SERVICE BULLETIN

Model: 8/10/12RESV(L)

Subject: Enclosure Hole Alignment with Mounting Pad,
GM92228-KP1-QS, GM92228-KP2-QS

Figure 1-1 M125A-10-80 Washer Dimensions

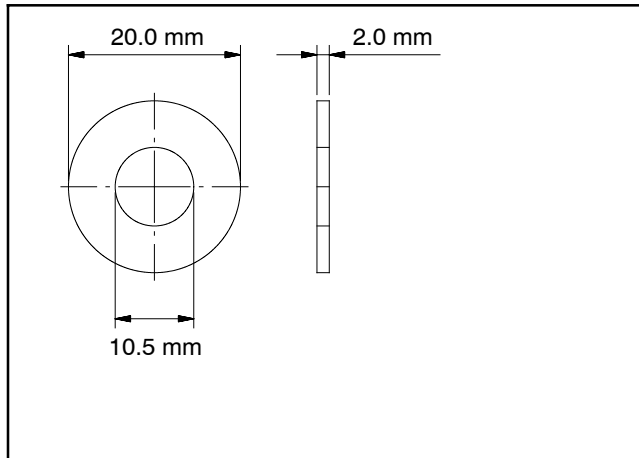
To align the holes in the 8/10/12RESV(L) enclosures with the threaded inserts in the mounting pad, the enclosure holes may need to be increased in size. Before enlarging the holes, obtain four washers required for the enlarged hole size.

- Drill
- 19/32 in. drill bit
- Metal File
- Washers, Qty. 4: 10.5 mm ID x 20.0 mm OD x 2 mm thick, zinc plated
Kohler Part Number: **M125A-10-80**
- **GM84772** touch-up paint bottle or **GM84771** touch-up paint spray can

- 1.4 Use the four bolts that come with the concrete pad and **M125A-10-80** washers to secure the generator to the mounting pad.

Note: Place the washer between the bolt head and the enclosure base.
